**Service Bulletin No: 24-009**  
**Modification No: INSPECTION**

**Ref No: 151**  
**ATA Chapter: 24**

**ELECTRICAL POWER - GENERAL**  
**INSPECTION FOR CHAFING ON AN ELECTRICAL HARNESS IN THE ENGINE COMPARTMENT**

Inspection  
Figure 1

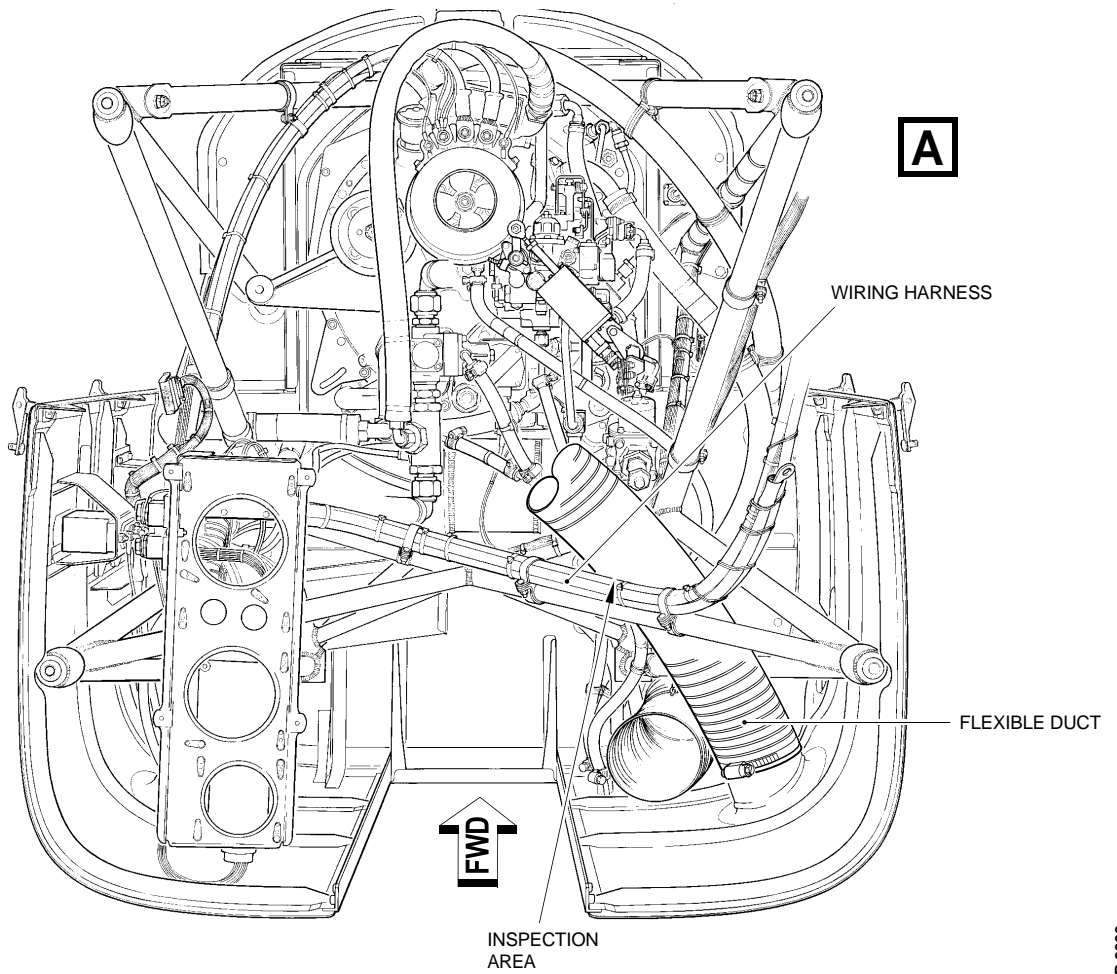
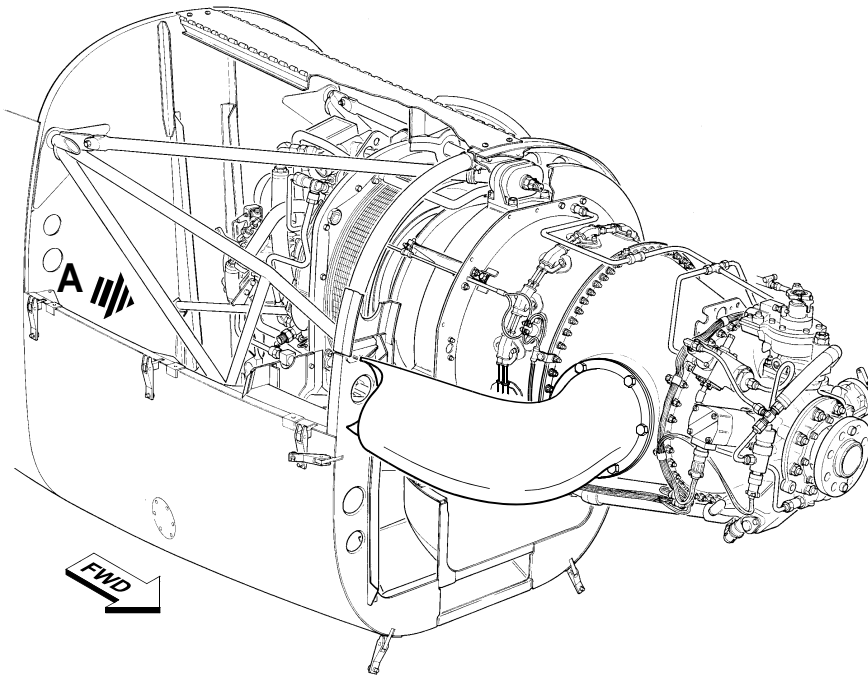
**B. Inspection (Ref. Fig. 1)**

- (1) Loosen the hose clamp at one end of the flexible duct.

- (2) Disconnect and move the flexible duct away from the inspection area.

- (3) Do a visual inspection of the flexible duct for chafing damage. If you find damage that makes the flexible duct unserviceable, remove and discard the flexible duct.
- (4) Use absorbent paper (Material No. P02-031) made moist with solvent (Material No. P01-011) to clean the harness in the area to be inspected.
- (5) Use a bright light source and mirror to do a visual inspection of the harness for chafing damage.
- (6) If you find chafing on the harness and you can see bare wires under the insulation you must replace the damaged electrical cable(s):
  - (a) Send details/photographs of the damaged cable(s) to this address to get replacement data:

**D. Installation (Ref. Fig. 1)**

- (1) Install the flexible duct and tighten the hose clamp(s).

**NOTE:** The flexible duct installation is shown in IPC 21-50-02, Fig. 02.
- (2) Use Koroseal binding (Material No. P09-004), as required, to secure the flexible duct to the engine mounting frame. Do this to prevent movement of the flexible duct which could cause chafing.

Repair  
Figure 2

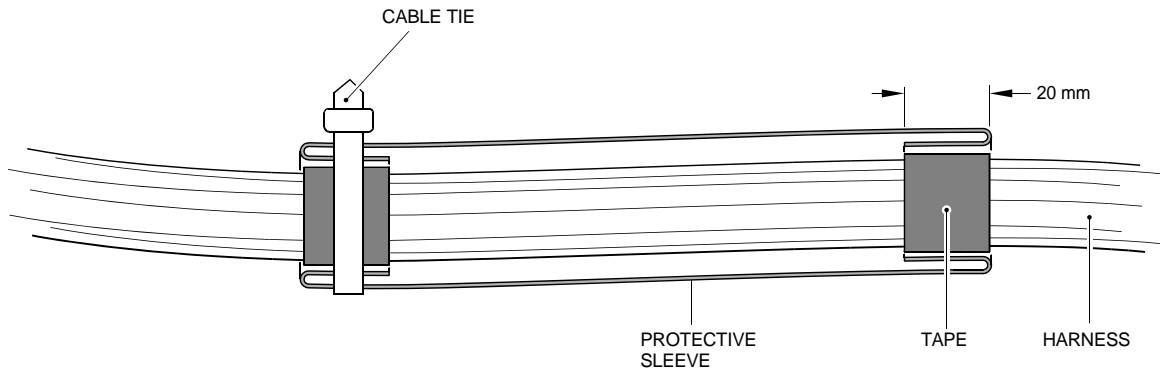
**C. Repair (Ref. Fig. 2)**

- (1) Remove the harness clamps and move the harness away from the engine mounting frame.
- (2) Use absorbent paper (Material No. P02-031) made moist with solvent (Material No. P01-011) to clean the harness where you will install the protective sleeve.

- (3) Make sure there are no cable ties around the harness where the protective sleeve is to be installed. Remove cable ties as necessary.
- (4) Cut a piece of the protective sleeve (P/N 917.96.92.154) long enough to cover the chafed area plus an additional 45 mm (1.75 in.) at each end. When you cut the protective sleeve:

- (c) Make sure no more fibers can come loose.
- (5) Wrap glass fiber tape (Material No. P09-020) around the harness at the ends of the repair area (as shown on Figure 2).

- (6) Fold 20 mm (0.75 in.) at the two ends of the protective sleeve inwards to make a double layer.
- (7) Wrap the protective sleeve around the harness with the doubled ends located over the glass fiber tape.

- (8) Install a cable tie (Material No. P09-017) at the ends of the protective sleeve to hold it in place.
- (9) If necessary, install additional cable ties (Material No. P09-017) on the harness. You can install cable ties over the protective sleeve if required.
